APPENDIX O2

Design Deviations

I-405, SR520 to SR522 Stage 1 (Kirkland Stage 1)

Draft RFP

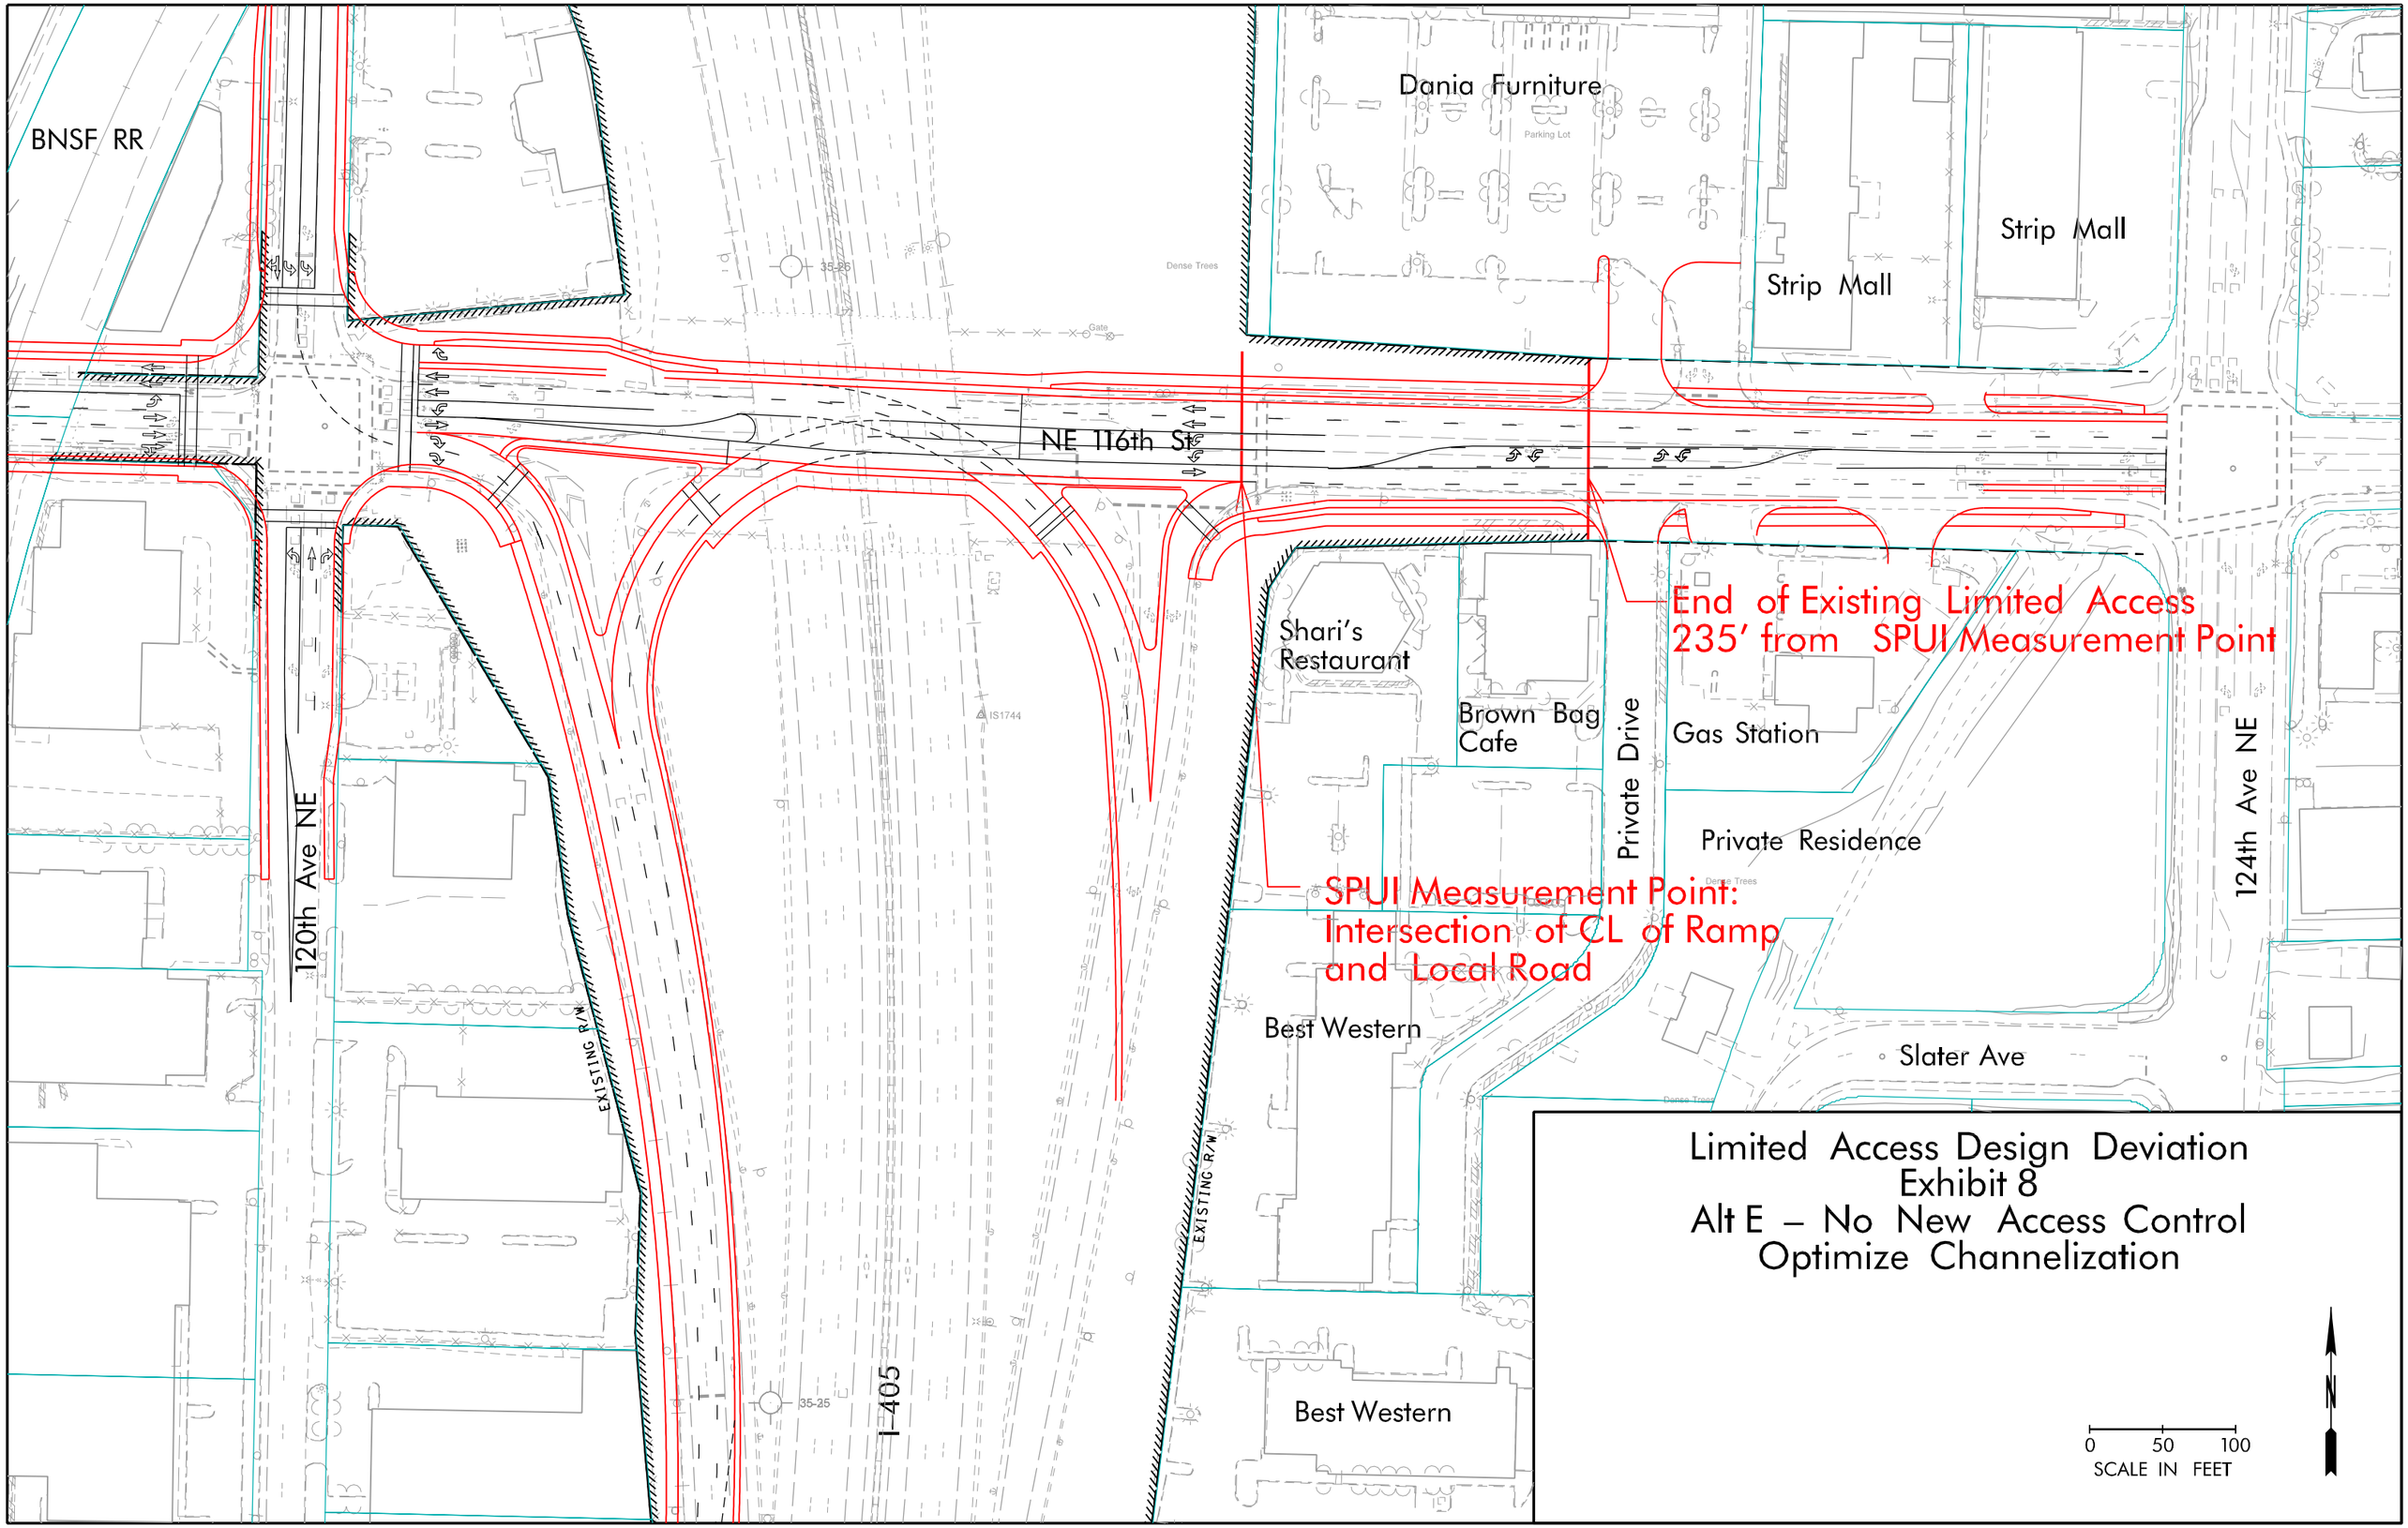
Alternative E No new Access Control (Exhibit 8) – Optimize driveway configurations and channelization to limit conflicting movements without purchasing additional access control along NE 116th St. Upgrading the existing half-diamond interchange to a half

SPUI and closing the driveways west of the interchange would also be included in this option. The Dania furniture driveway will be relocated to align directly with the private driveway. The gas station driveways will remain in their existing location. Limited access would extend 235 feet from the reference point on the SPUI ramp.

The recommended alternative (Alternative E, Exhibit 8) is to not buy additional access control and to optimize driveway configurations and channelization to limit conflicting movements. The Dania furniture driveway will be relocated to align directly with the private driveway. The gas station driveways will remain in their existing location. Limited access would extend 235 feet from the reference point on the SPUI ramp.

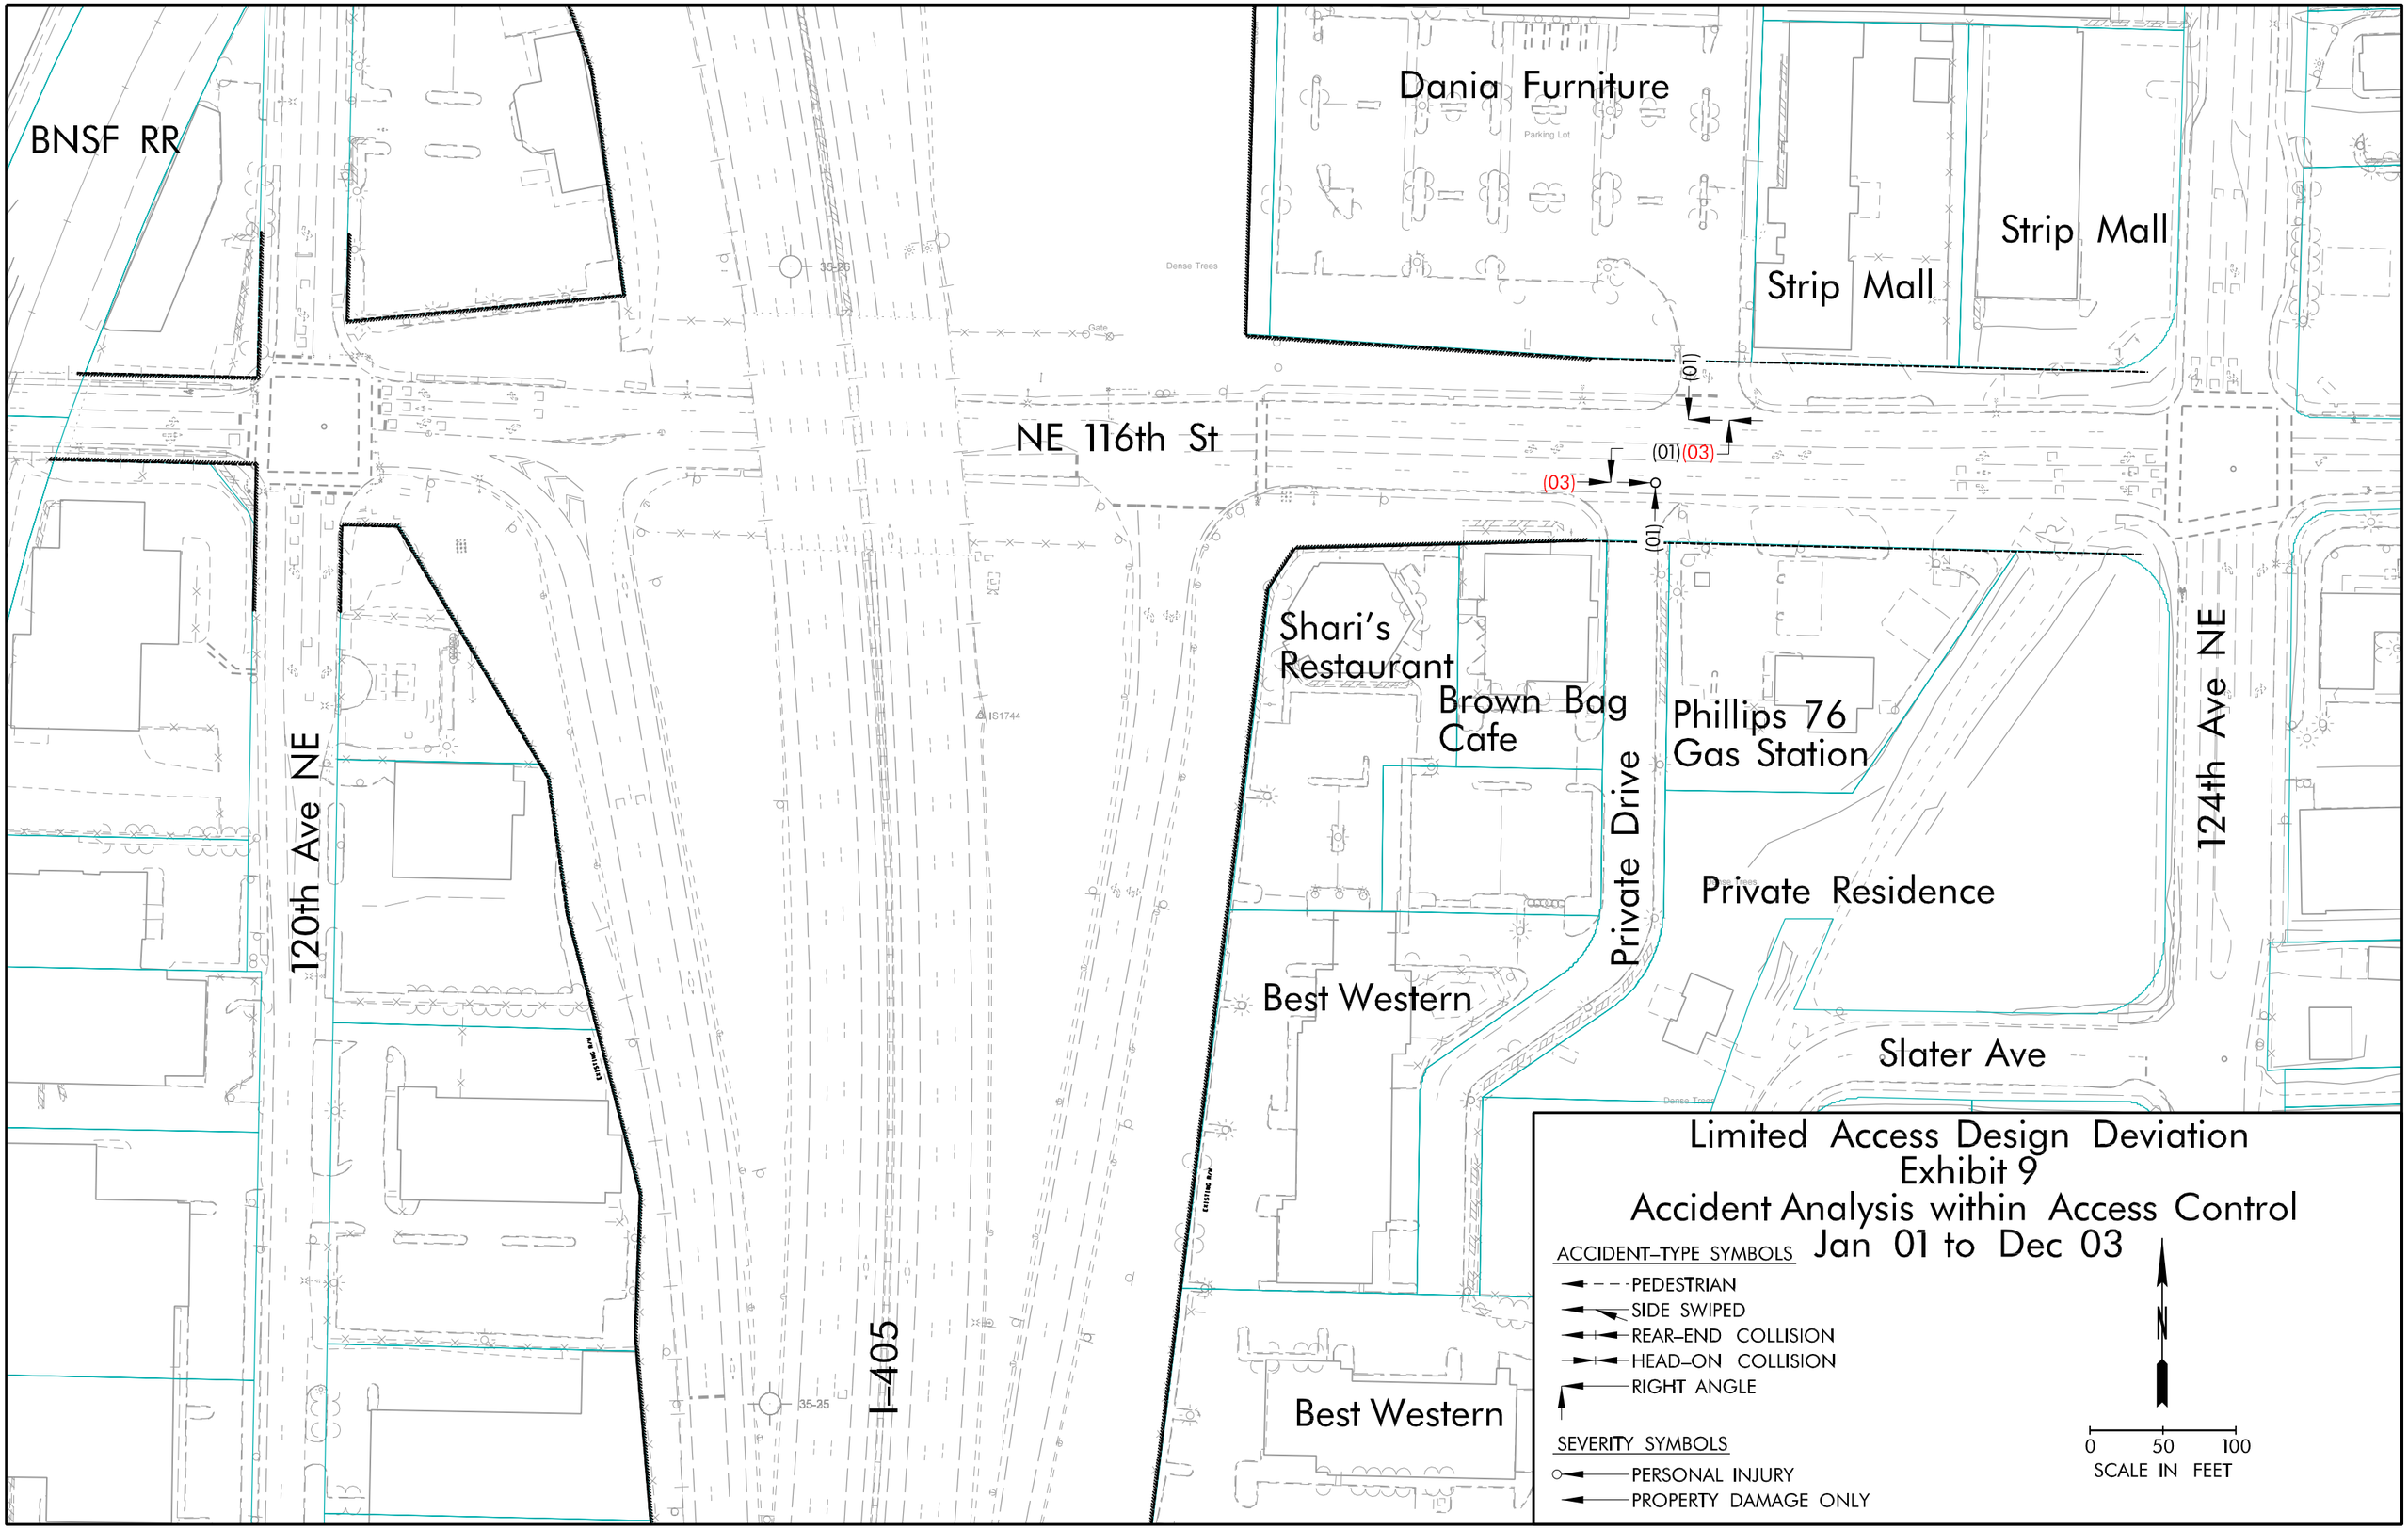
- The accident data furnished by the City of Kirkland supports this alternative with its limited modifications to the existing driveways and channelization. Exhibit 9 shows the five accidents within the area of limited access discussion including the Dania and the private driveway. Four of the accidents, including one injury, were associated with vehicles making lefts turn movements at either Dania or the private access driveway. The fifth accident in this area was a vehicle turning right out of the Dania driveway. It is the policy of NW Region Access Management to further control a driveway if five (5) left turning accidents occur in a three year span, including at least one each year. Based on that standard, none of the existing driveways qualify for further control. Dania and the shared access driveway each had one accident in 2001, none in 2002 and one in 2003.
